# RENESAS TECHNICAL UPDATE

Product Category	MPU/MCU		Document No.	TN-H8*-A439A/E	Rev.	1.00
Title	Error correction regarding EERPOM Blank Check Control Register.		Information Category	Technical Notification		
Applicable Product	H8SX 1720 Group, H8SX 1720S Group	Lot No.	Reference Document	Refer to the "Reference Documents" section below		
		All lots

We would like to inform you of the correction of errors regarding EEPROM Blank Check Control Register in the H8SX 1720/1720S Group Hardware Manuals.

Figure1 . Address range in case of setting all bits of BCADR[10:0] to "1" and the rightfully necessary address range.

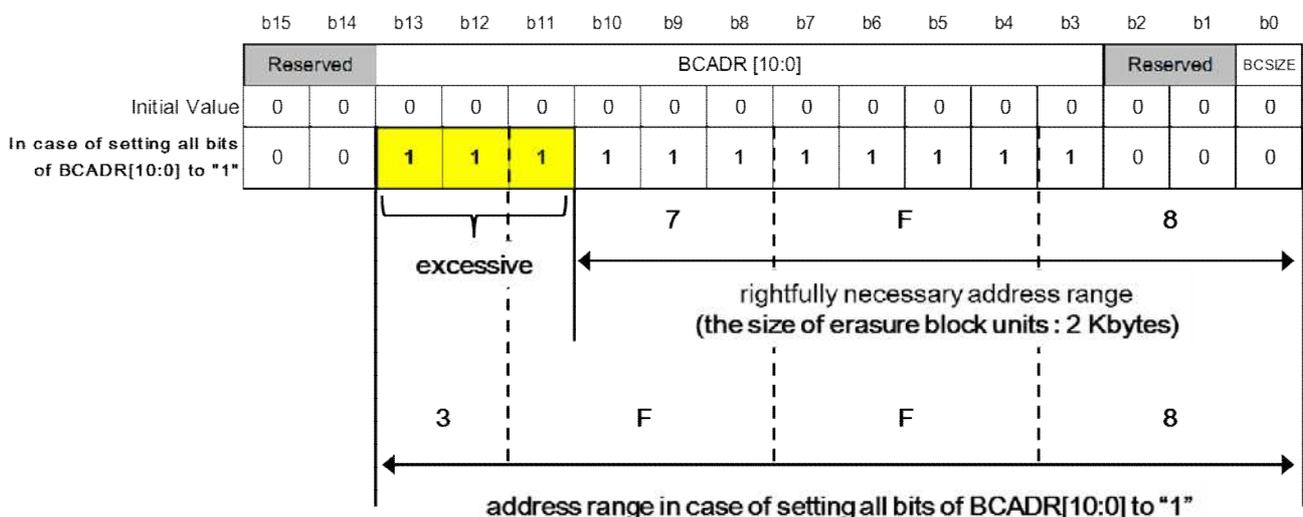
When BCSIZE is 0 and BCADR bits specify the start address for blank checking, if any bit of BCADR[10:8] were set to "1", the size of the area for blank checking would exceed the size of erasure block units (2Kbytes). Therefore the write value of BCADR[10:8] should always be all "0" to prevent a malfunction.

Figure 1 shows the address range when all bit of BCADR[10:0] are set to "1" and the rightfully necessary address range.

Figure 2 . Example of malfunction ( Case1 )

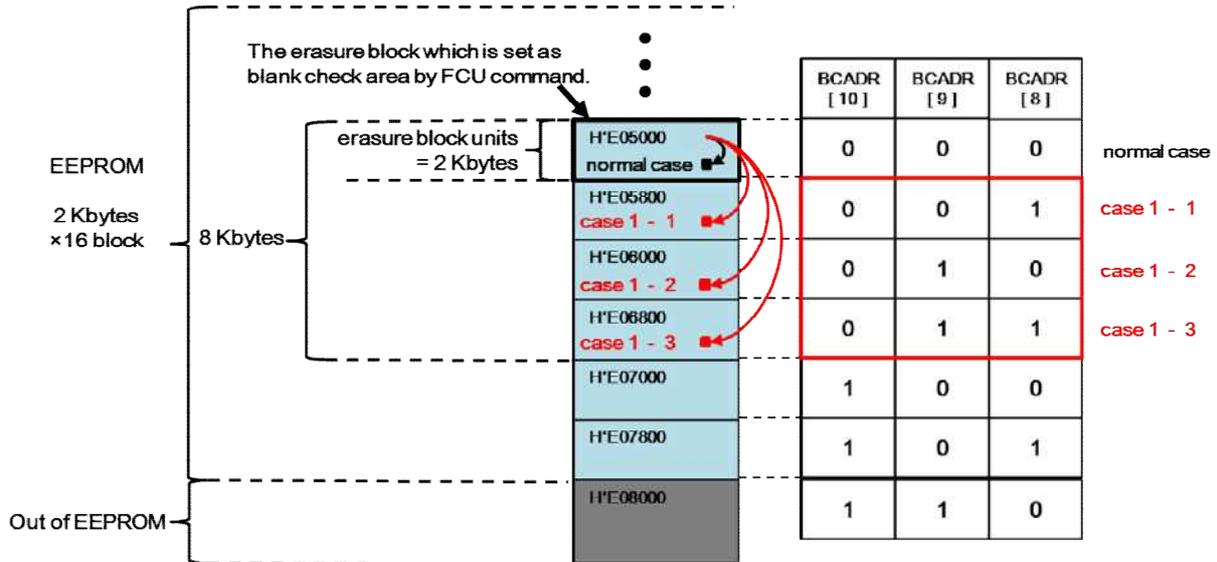
**(1) Case 1: 2 Kbytes BCADR[10:0] setting < 8 Kbytes ( Figure. 2)**

->The other erasure block will be blank-checked than the set erasure block.

Figure 3 . Example of malfunction ( Case 2 )

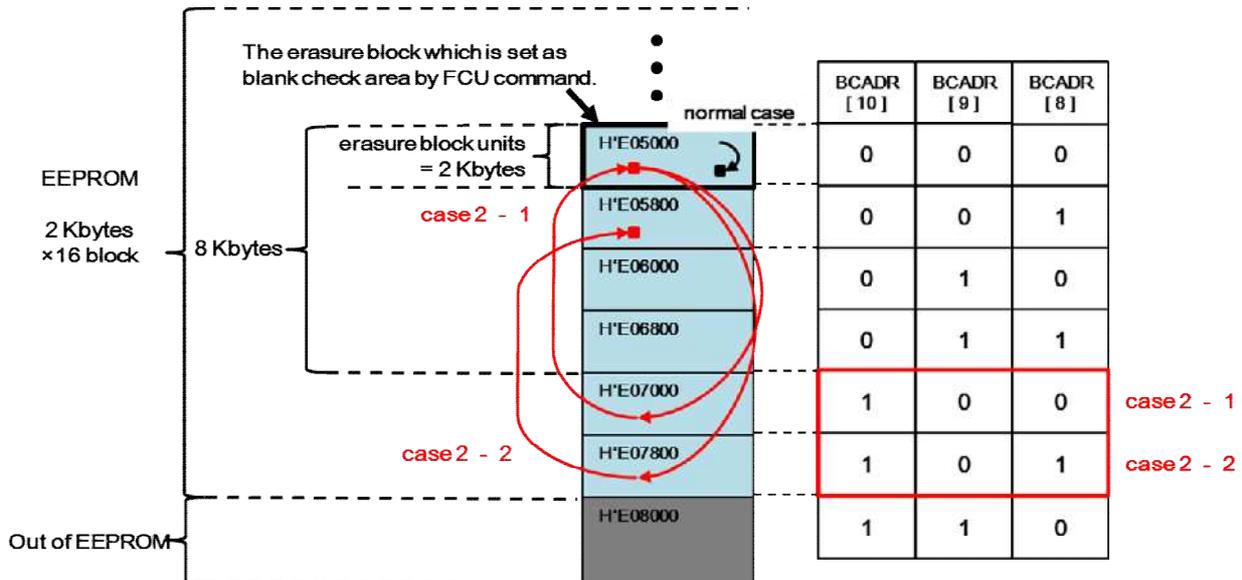
**(2) Case 2: 8 Kbytes BCADR[10:0] setting ( Figure. 3 )**

->The address more than 8 Kbytes returns to the top of the set eraser block and the recalculated address block will be blank-checked.

Figure 4 . Example of malfunction ( Case 3 )

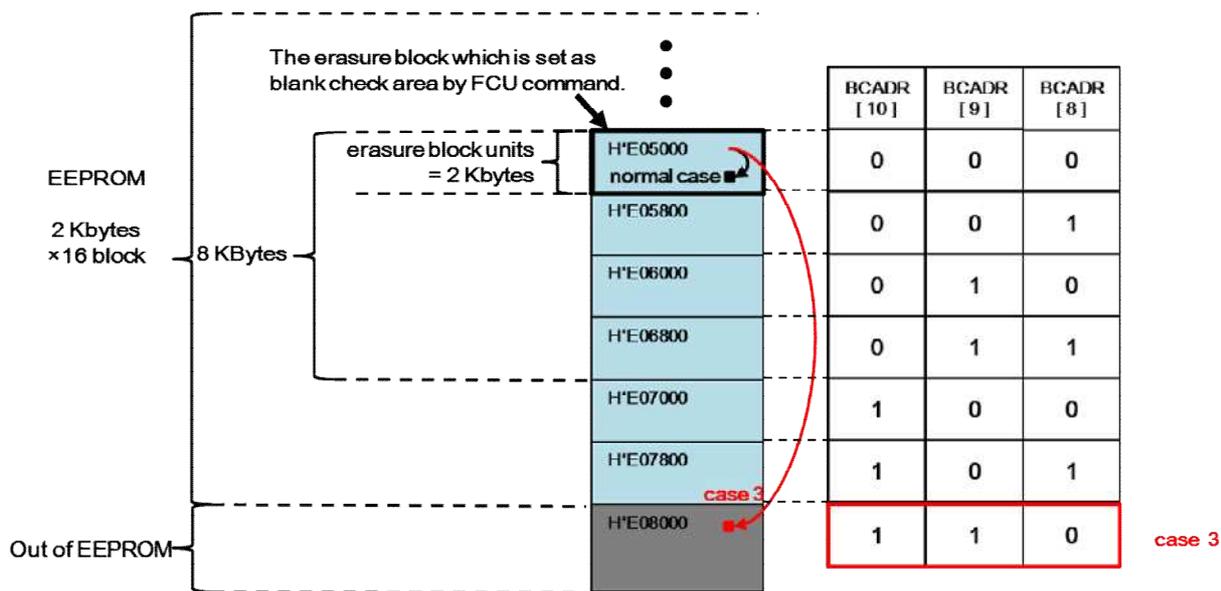
**(3) Case 3 : Setting the address beyond the EEPROM area ( Figure. 4 )**

->FCU firmware will return the result of blank check which is not guaranteed. And the error will not occur.
